RESPONSE TO FURTHER ISSUES (MARCH 2015) - RECONFIGURING A LOT (1 INTO 72 LOTS AND PARK) VIXIES ROAD, WONGA BEACH Property Description: Lot 32 on SP126925

Property Location: Vixies Road, Wonga Beach

Council Reference: 8/13/1481

CONTOUR AND DRAINAGE PLAN - SHEET 1 OF 3

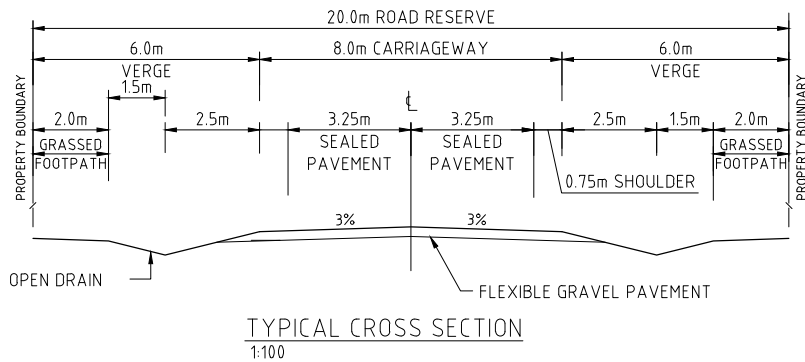
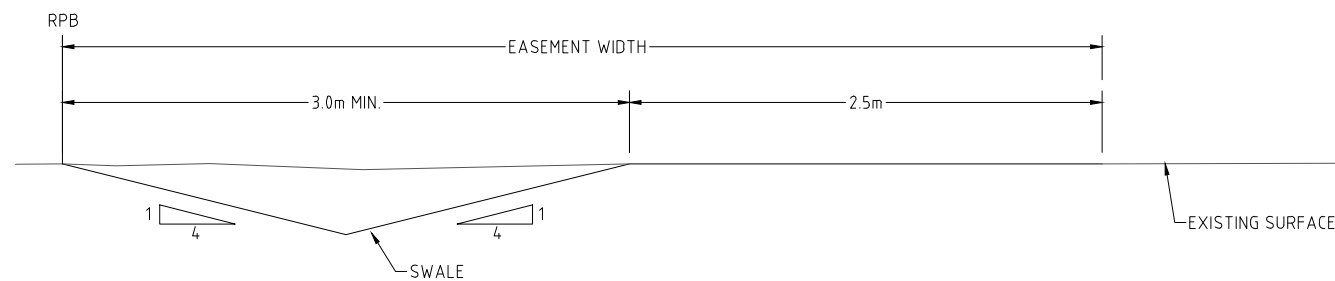
- c. Access within the side boundary easements; the text advises that these will be made wider to allow access, please provide a typical section and confirm dimensions to facilitate this.***

Drawing C01 has been amended to show the drain and access detail.

SIDE DRAIN AND ACCESS DETAIL
SCALE 1:20

CONTOUR AND DRAINAGE PLAN - SHEET 2 OF 3

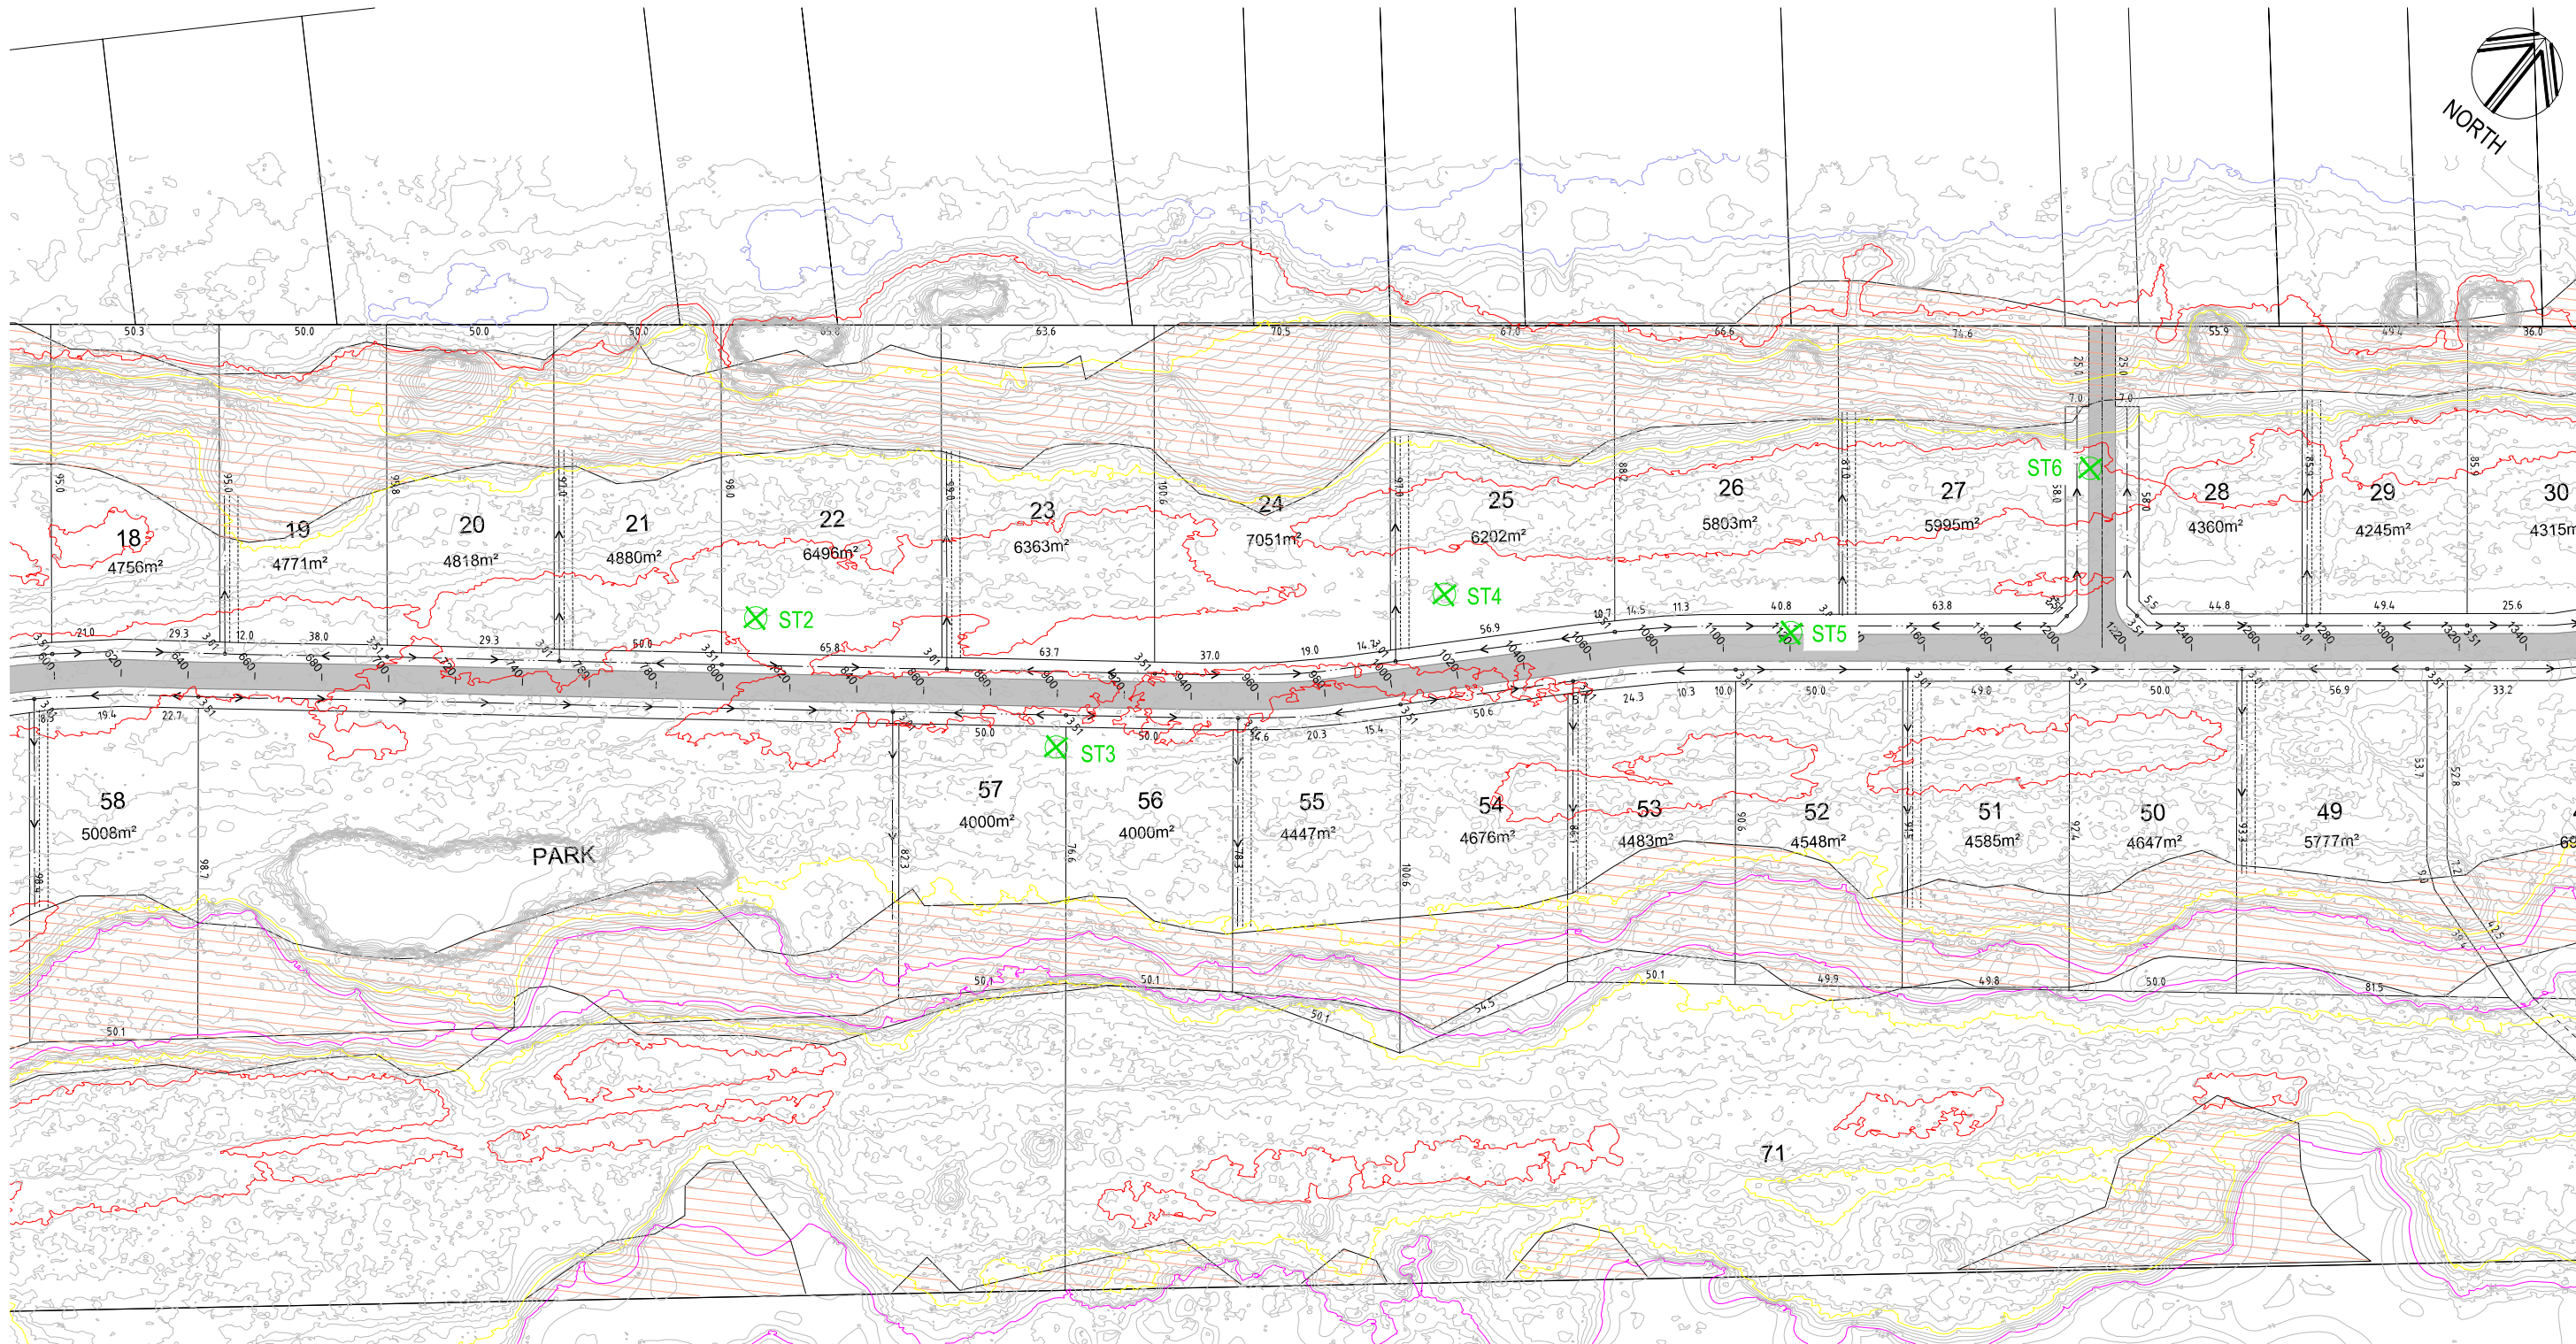
- e. Does the topographical data in the model include sufficient detail to reflect the access crossing to the north of lot 38 that exists now?**

It is assumed that this query relates to the existing access crossing to the north of Lot 28, not Lot 38. The existing beach access road through Lot 28 is included in the model. The minimum level of the access road over the swale through Lot 28 is approximately 2.4 m AHD. The topographical detail in this area is shown in Cardno Drawing Q144007-001-C02 in Appendix D of the Flood Study.

CONTOUR AND DRAINAGE PLAN - SHEET 3 OF 3

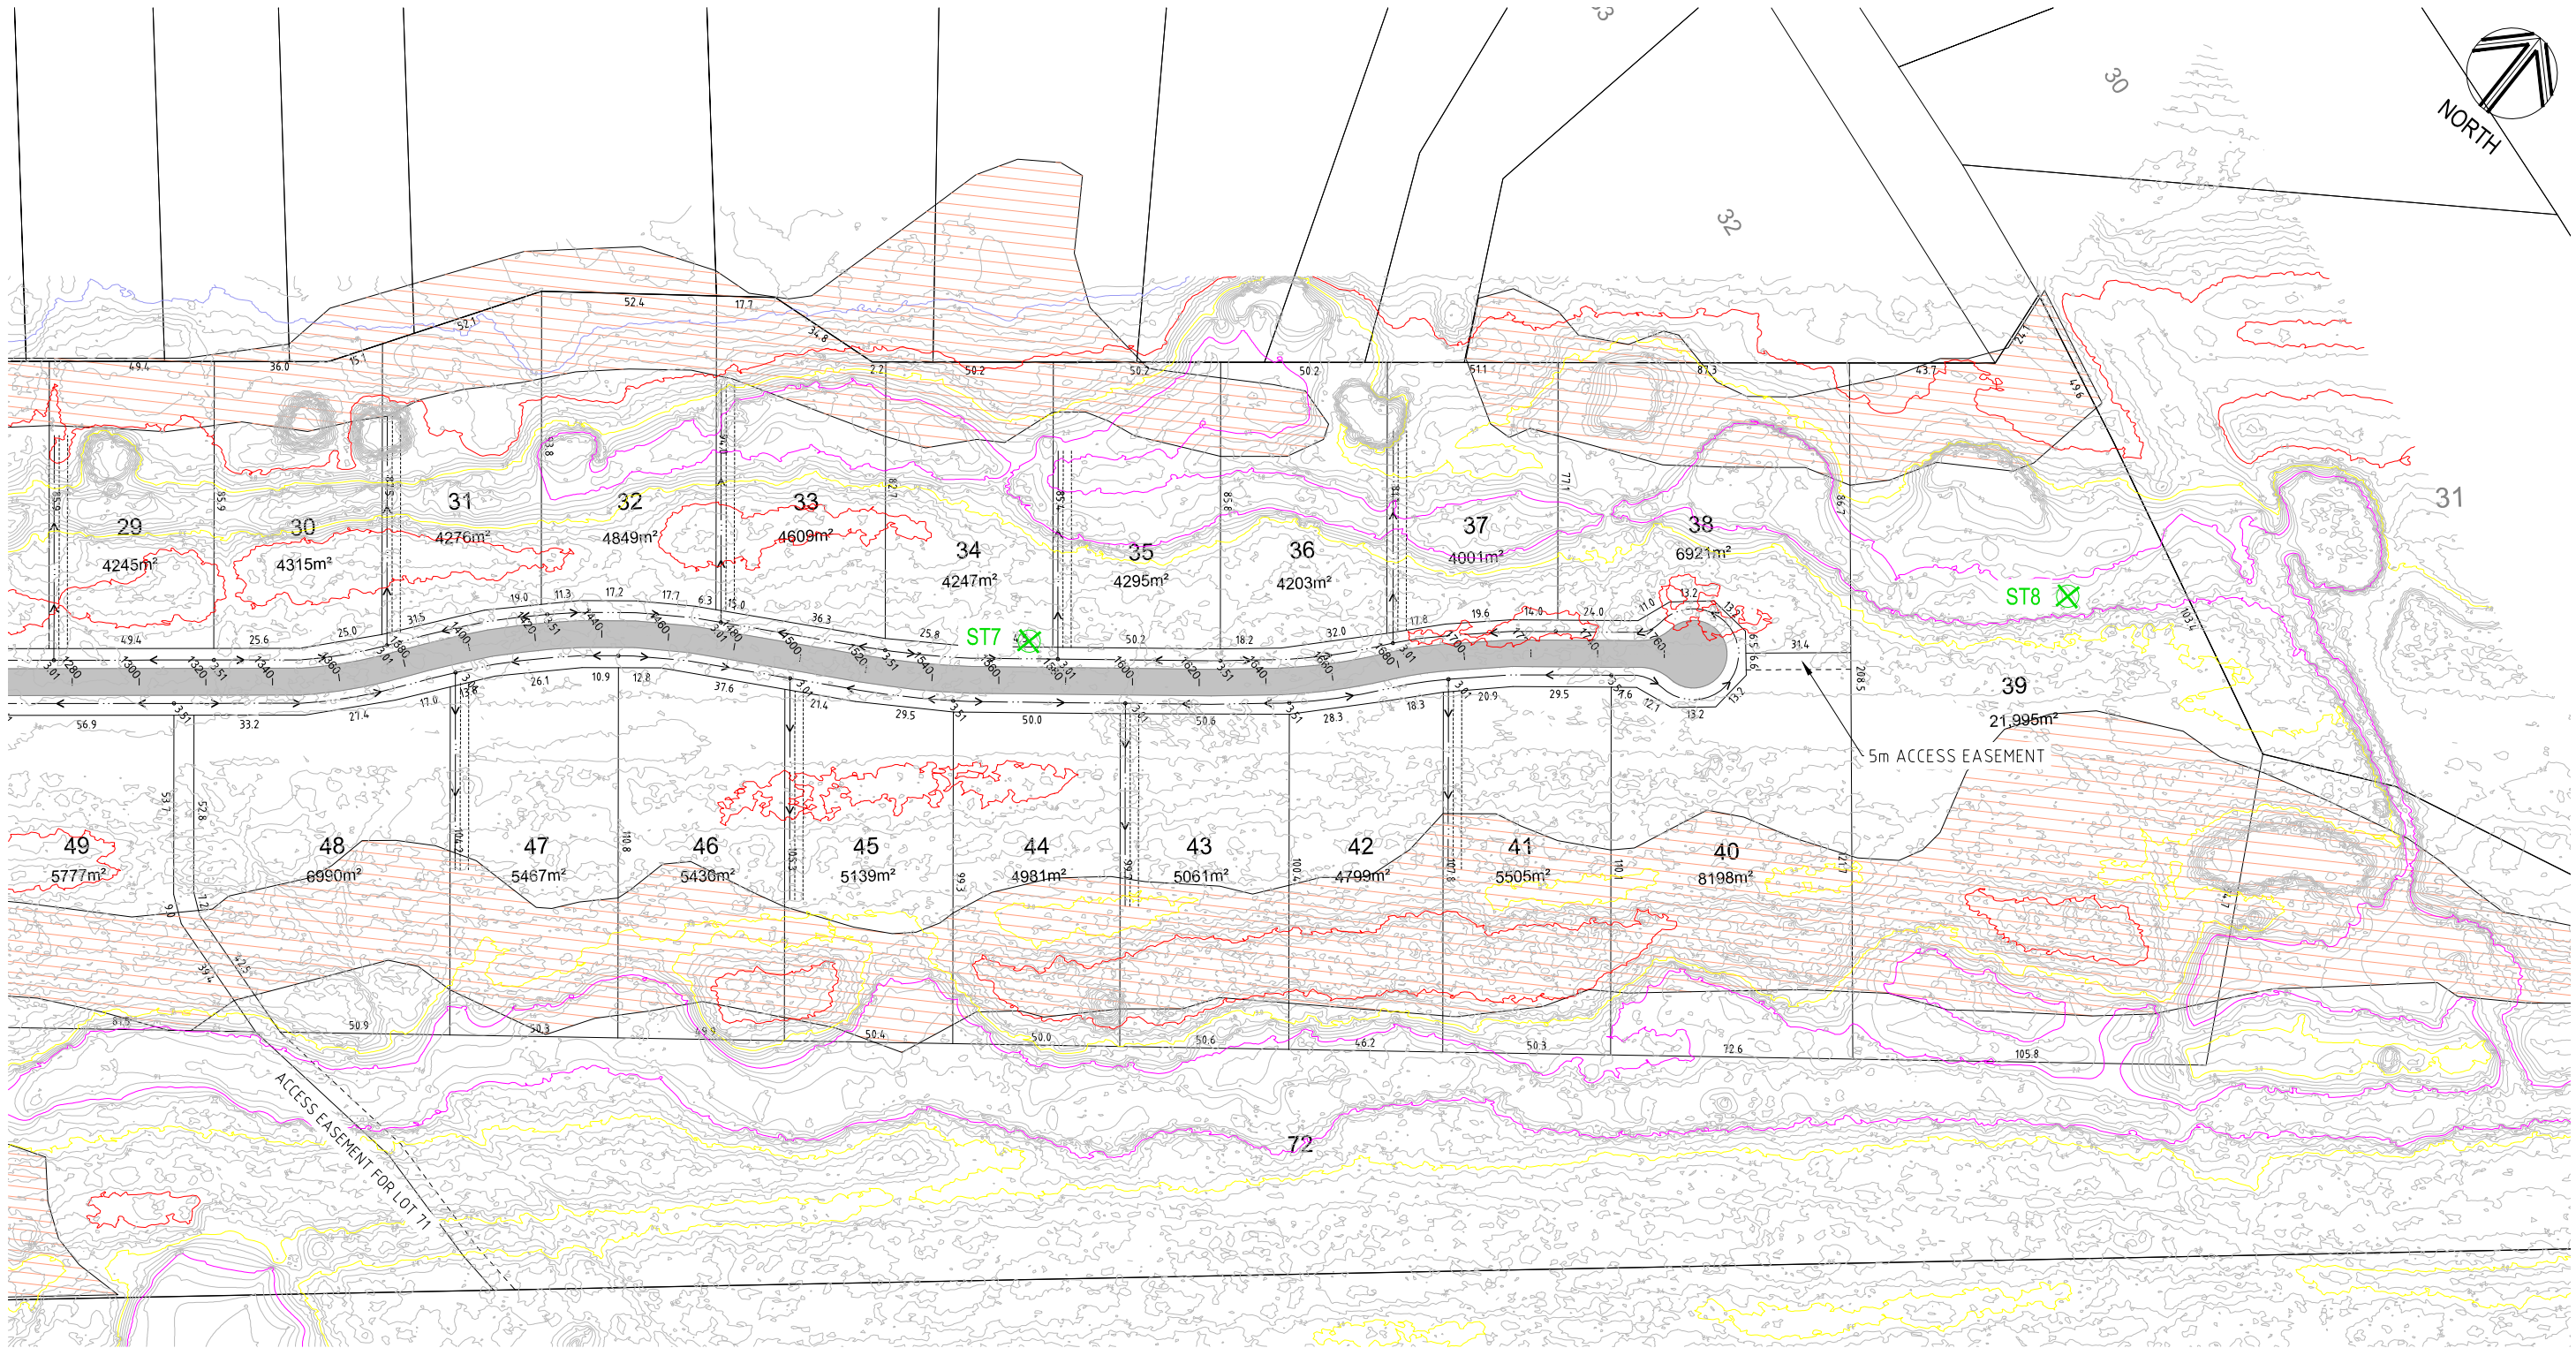
- c. Does the modelling consider the implications (afflux, channel restrictions) for the proposed crossing of the drainage channel for the access to proposed lot 39 off South arm drive.***

It is not proposed to construct a road access to Lot 39 from South Arm Drive. An access will now be provided from the internal road within the site. A revised development layout plan showing this access is attached on drawing C03.
